VAIL VALLEY DESIGN CENTER

TOWN OF EAGLE | REFERRAL RESPONSE
1215 CHAMBERS AVENUE

Town of Eagle
Community Development Department
Attn: Alyssa Rivas, Planner
Re: 1215 Chambers Avenue – Referral Response Overview Letter
Development Plan & Lot Consolidation (DR25-04 & LLA25-02)

Manning Pipe Calculator

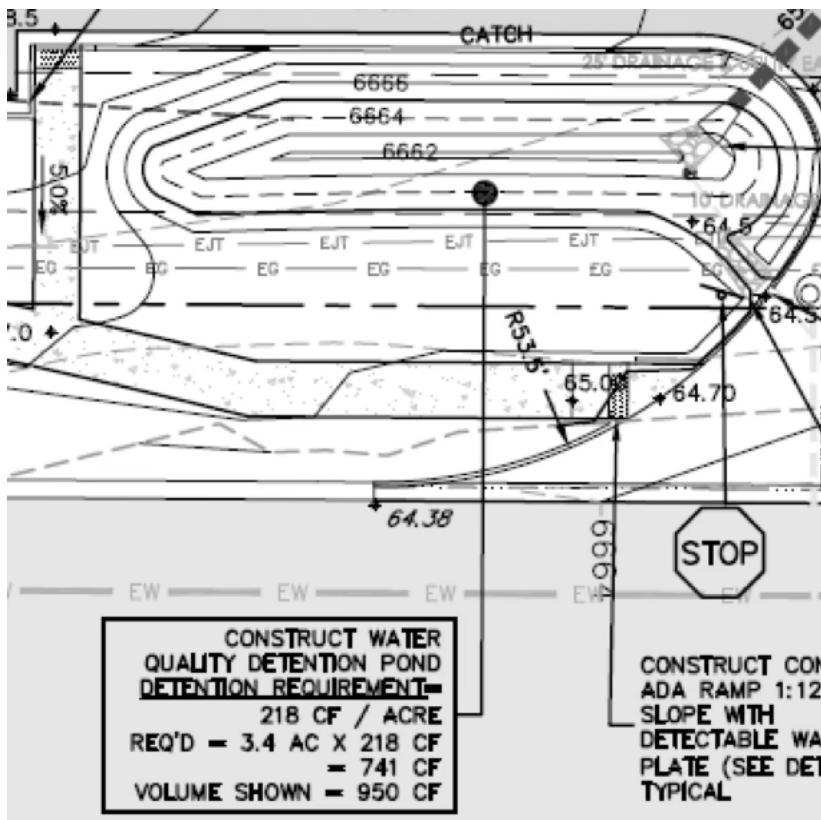
p. 84. The storm system has been revised slightly since the reviewed drainage report. There are now sections of 24" pipe at 1.0% slope. Revised Calculations are shown below.

A 24" pipe at 10.6 cfs (100 year event) will be 9.4" full.

Greater Eagle Fire
Hydrant Layout Coordination

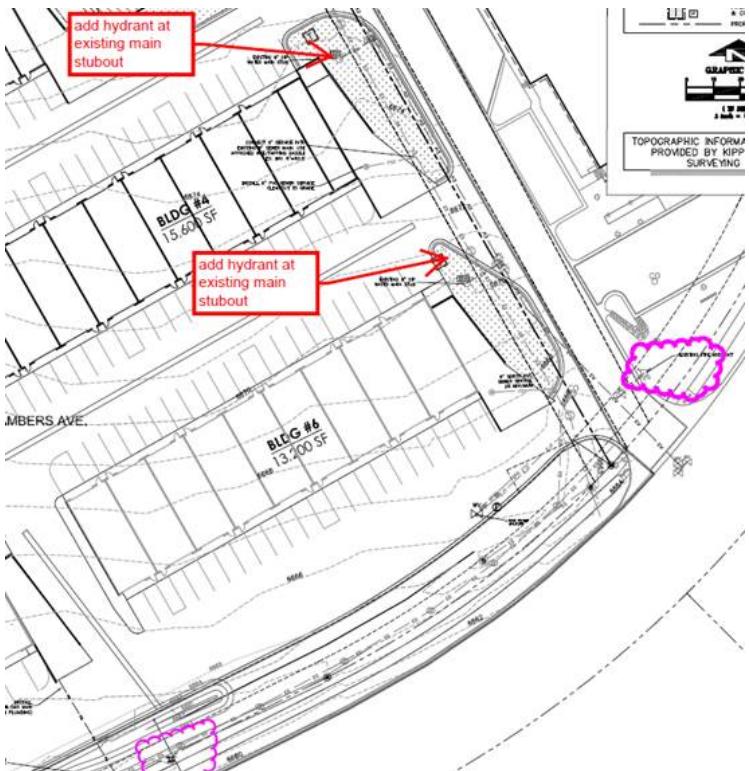
I have included a plan showing the (3) existing fire hydrants surrounding the property. Are these (3) adequate for your use?

We could also add an additional hydrant at an existing main stub (boxed text in RED).

We will add (2) hydrants as discussed and shown below.
There are existing water main stubs at these locations, which can be put into use and not abandoned.
